Title: SATA Redriver & SCREW PAD		
Size: SS5	Document Number:	Rev 1A
Date: Friday, September 12, 2008	Sheet 2	of 3

Change List

17	1	9/10/2008	EE	Add DMIC signal	Add CN2	
				<div> QUANTA COMPUTER</div>		
PROJECT : SS5		DOC. NO. : 204		REV: X00		Title Change List1 QUANTA
APPROVED BY : Cory Lin		CHECKED BY: Cory Lin		DRAWN BY : Leo Tseng		Size Document Number SS5 Rev 1A
				DATE : May. 19 , 2008		COMPUTER

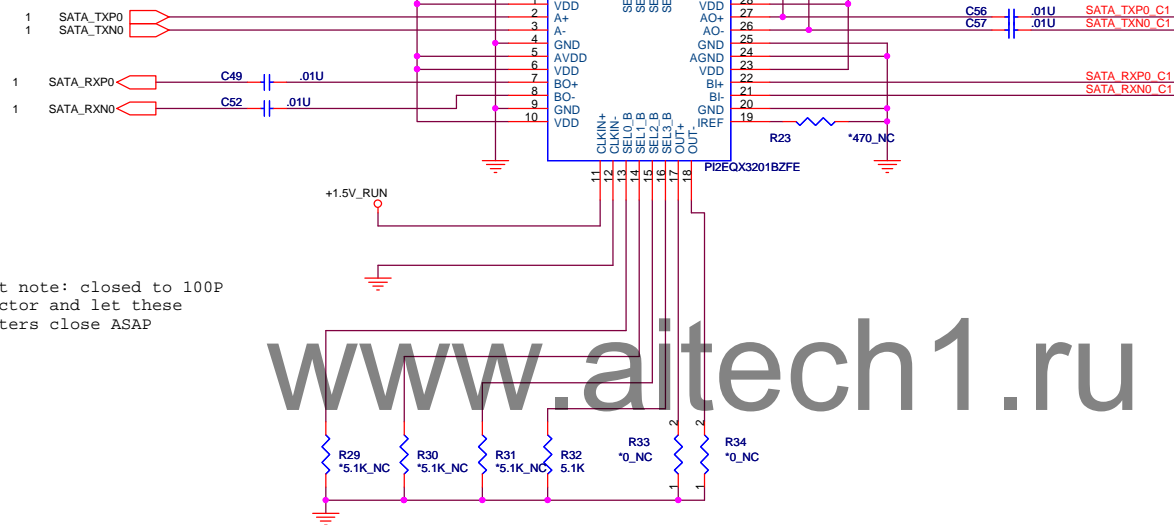
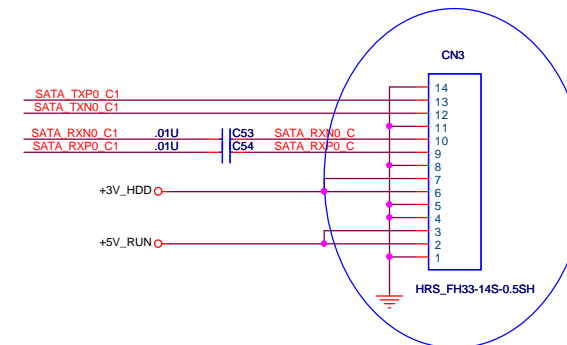
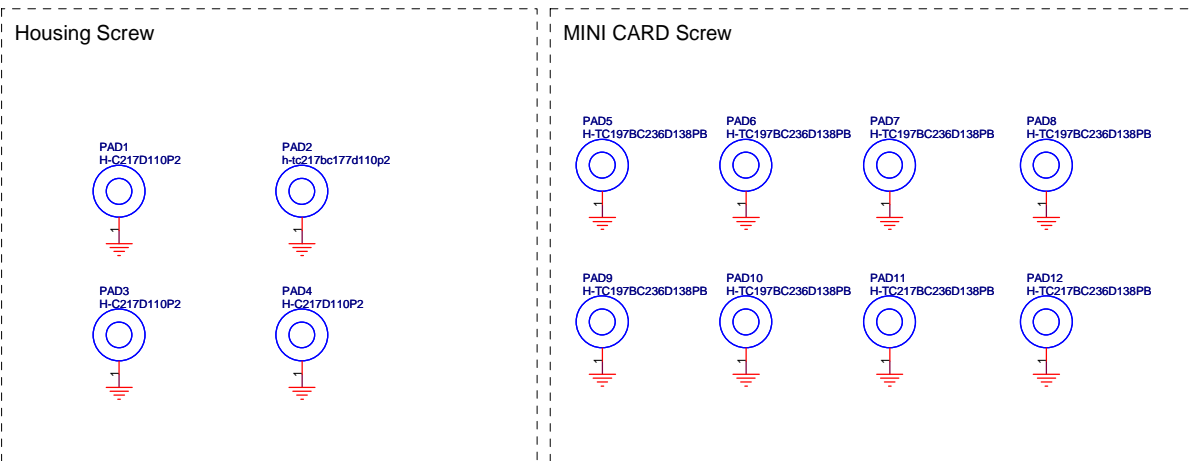
8	2	5/27/2008	EE	Swap SATA signals for SATA can't detect issue.	Swap SATA_TXP/N0, SATA_RXP/N0 signals for SATA issue.	X00.1
9	2	5/29/2008	EE	Follow Pericom feedback. Add pull-up 4.7k ohm at EN_A, EN_B.	Pull-up R51, R52 4.7k ohm at U2.30, U2.29 pin.	X00.1
10	1	5/30/2008	EE	Update SIM card pin define.	Update JSIM symbol pin define.	X00.1
11	1	5/30/2008	EE	Confirm with TP vendor. TP don't need +3.3V_ALW.	Delete CN1 pin 5 +3.3V_ALW.	X00.1
12	2	5/30/2008	EE	Follow Pericom feedback. Add 0.1uF on AO.	Add C56, C57 0.1uF at U2.26, U2.27.	X00.1
				X00.1 change to X01		
13	1	6/26/2008	EE	Follow ME design change	change SIM card connector footprint and P/N	X01
				X01 change to X02		
14	1	9/10/2008	EE	Remove 0 ohm.	Remove R1,R3,R4,R47,R48,R5,R49,R50,R6	X02
15	2	9/10/2008	EE	Remove 0 ohm.	Remove R39,R40,R41,R42,R43,R44,R45,R46,R25,R26,R22,R24,R27,R28,R35,R36,R37,R38	X02
16	2	9/10/2008	EE	Remove Hall IC function from MINIPCIE board	Remove R14,U3,U4,C37	X02
